# Access Compliance Report

## Public Rights-of-Way

### (Curb Ramps)

Intersection ID: 45061	Main Street: EVANGELION_CT	Cross Street: REDDING_GLEN_AV	Location: SE
ADA ID: 67C9BB022BDB	Ramp Type: BlendTrans1	Initial Pass/Fail: Fail	Overall Compliance: No
Severity Score: 10			
Codes/Mitigation Info/Possible Solution		Field Measurements/Component Compliance

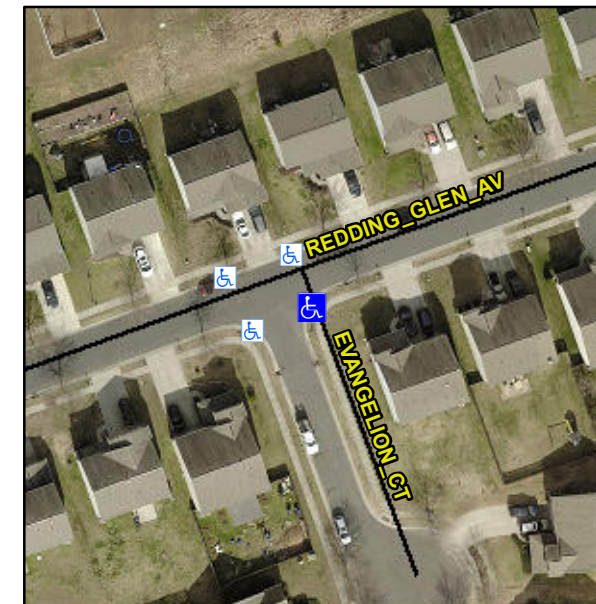
**Not Found, R304.5.1, R304.5.3**

Compliance	Description	Data	Compliance	Description	Data
N/A	Ramp Length (in)	47.0	Yes	BlendTrans Slope (%)	4.4
No	Ramp Width (in)	47.0	No	BlendTrans XSlope (%)	2.7
N/A	Flare Type LT	N/A	N/A	Flare Type RT	N/A
N/A	Flare Slope LT (%)	N/A	N/A	Flare Slope RT (%)	N/A
N/A	Flare Traversable LT?	N/A	N/A	Flare Traversable RT?	N/A
N/A	Landing Length (in)	N/A	N/A	DWS Provided?	N/A
N/A	Landing Width (in)	N/A	N/A	DWS Contrast?	N/A
N/A	Landing Slope (%)	N/A	N/A	DWS Length (in)	N/A
N/A	Landing X Slope (%)	N/A	N/A	DWS Full Width?	N/A
N/A	Landing Curb? (Y/N)	N/A	N/A	DWS Offset (in)	N/A
N/A	Shared Landing?	N/A			
N/A	Gutter Ponding?	N/A	N/A	Gutter Slope (%)	N/A
N/A	Gutter Lip Ht (in)	N/A	N/A	Gutter X Slope (%)	N/A
N/A	Painted X Walk1?	No	N/A	Painted X Walk2?	No
	X Walk 1 Direction	To N		X Walk 2 Direction	To W
	X Walk 1 Width (in)	N/A		X Walk 2 Width (in)	N/A
	X Walk 1 Slope (%)	3.1		X Walk 2 Slope (%)	0.1
	X Walk 1 X Slope (%)	2.0		X Walk 2 X Slope (%)	0.1

N/A	Ramp inside XWalk1?	N/A	N/A	Ramp inside XWalk2?	N/A
	Road Slope (%)	4.0		Clear Space?	N/A
	Road X Slope (%)	0.8	N/A	Clear Space to XWalk (in)	N/A
N/A	Any Obstructions?	N/A	N/A	Storm Grate/Utility Hazard?	N/A
	Obstruction Type			Storm Grate/Utility Type	
		N/A			N/A
			Yes	Surface Condition? (G/P)	Good
			No	Curb Slope (%)	14.3

**Remove & Replace Curb Ramp With Two New Directional Ramps or Equivalent.**
